## SUTHERLAND SHIRE COUNCIL ADDENDUM ASSESSMENT REPORT

<b>Panel Reference</b>	<b>2017SSH019</b>
<b>DA Number</b>	<b>DA17/0467</b>
<b>LGA</b>	<b>Sutherland Shire</b>
<b>Proposed Development:</b>	<b>Refurbishment and restoration of Heathcote Hall, construction of 35 townhouses and 20 apartments, associated landscape works and 56 lot strata subdivision</b>
<b>Street Address:</b>	<b>Lot 1 &amp; 2 DP 725184 (No. 1-21) Dillwynnia Grove, Heathcote</b>
<b>Applicant/Owner:</b>	<b>Ink Architects Pty Ltd</b>
<b>Date of DA lodgement</b>	<b>28 April 2017</b>
<b>Number of Submissions:</b>	<b>55 groups/individuals from formal post meeting notification period (November 2018), and 3 groups/individuals from May/June 2019 notification</b>
<b>Recommendation:</b>	<b>Refusal</b>
<b>Regional Development Criteria (Schedule 7 of the SEPP (State and Regional Development) 2011</b>	<b>Schedule 4A of the Act (in accordance with current version of the EP&amp;A Act at the time of lodgement)</b>

<b>Report prepared by:</b>	<b>Lisa Pemberton, Assessment Officer Sutherland Shire Council</b>
<b>Report date</b>	<b>2 August 2019</b>

*Figure 6 CMP development zones overlaid on proposed site layout*

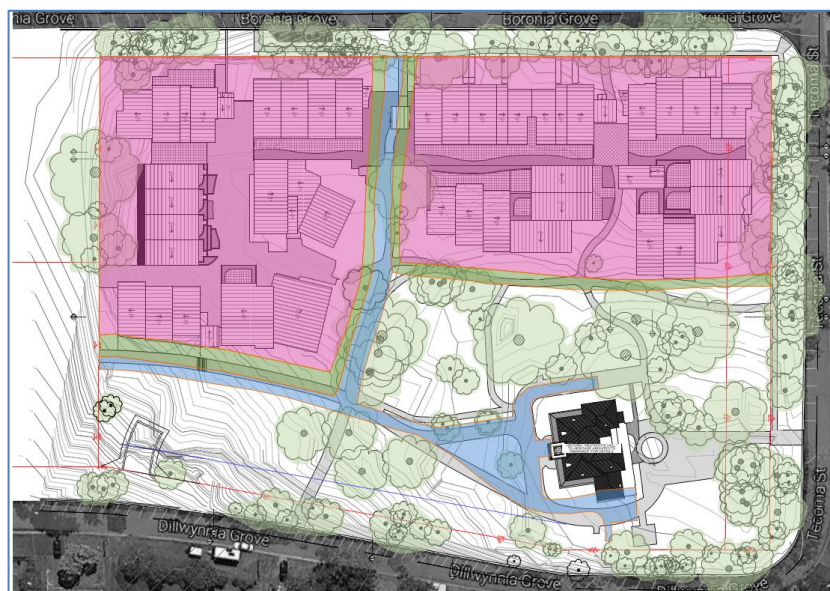
In response to the deferred matter regarding the development and setback zones, the applicant has also provided a plan identifying the conservation zones, former carriageway, buffers and areas where development is permitted in accordance with the CMP, see Figure 6 below.

Figure 10 Height Plane of Building B showing extent of non-compliance (as per Plan DA10HP Issue C)

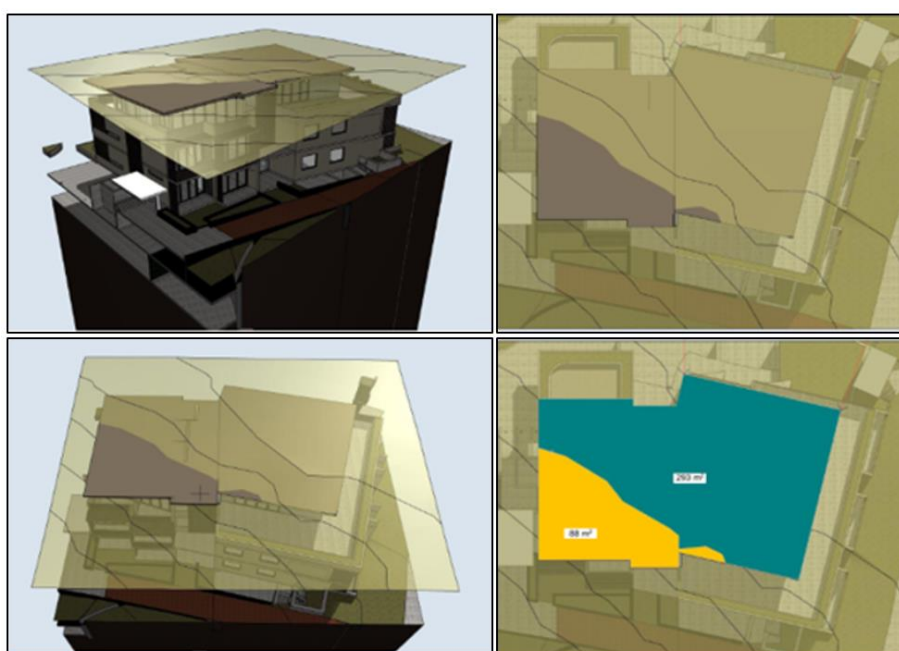
The applicant has provided a diagram indicating the extent of non-compliance regarding Building B (Figure 10 below).

According to the applicant, Figure 10 demonstrates of the 381m<sup>2</sup> roof area, 88m<sup>2</sup> or 23% of this area is over the 8.5m building height plane.

Figure 12 Second Floor Plan (left) and Roof Plan of Building B (right), as currently proposed.

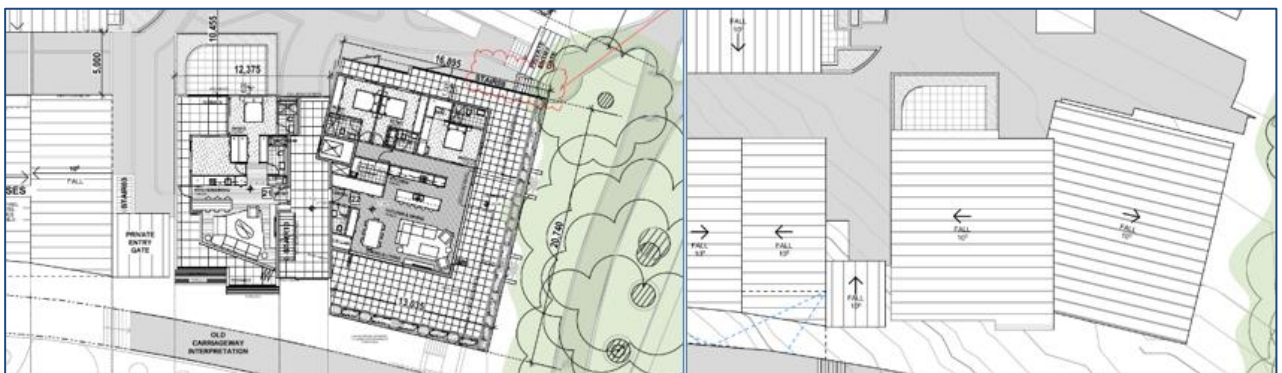
A comparison of the current plans and the plans presented to the SSPP on 28 June 2018, indicate that the second floor plan/layout of Building B has not changed, however the roof has been extended towards the south and east, increasing the apparent bulk of Building B, as seen in Figure 11 and Figure 12 below.

Whilst a partial reduction in height of Building B has occurred the figures below demonstrate that, the roof has been extended and will be more visible from the public domain. The non-compliant height and extended roof height cannot be supported.

Figure 13 Western view of the site, with the residential flat buildings identified in red.

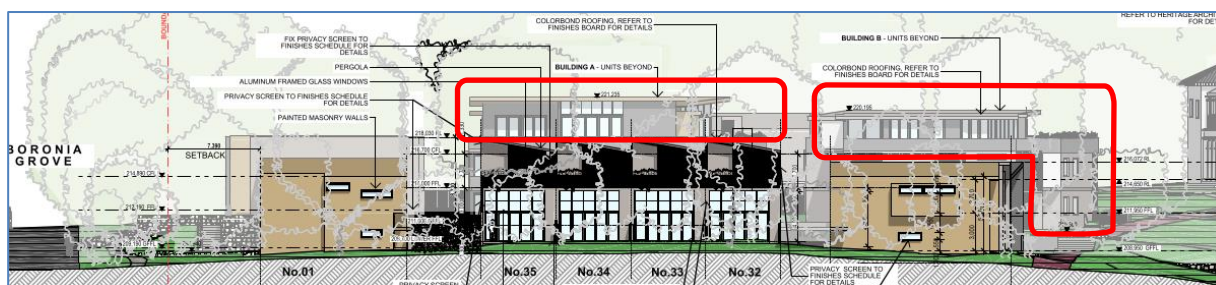
The height of each of the proposed residential flat buildings has not adequately addressed nor resolved the visual intrusion upon the locality and adjoining properties as demonstrated in Figure 13 and Figure 14 below, as per Clause 4.3 (1)(c) and (d) of the SSLEP 2015. The residential flat buildings will be

visible in particular from the west and south. The applicant has failed to minimise the visual intrusion in response to the Deferred Matters.
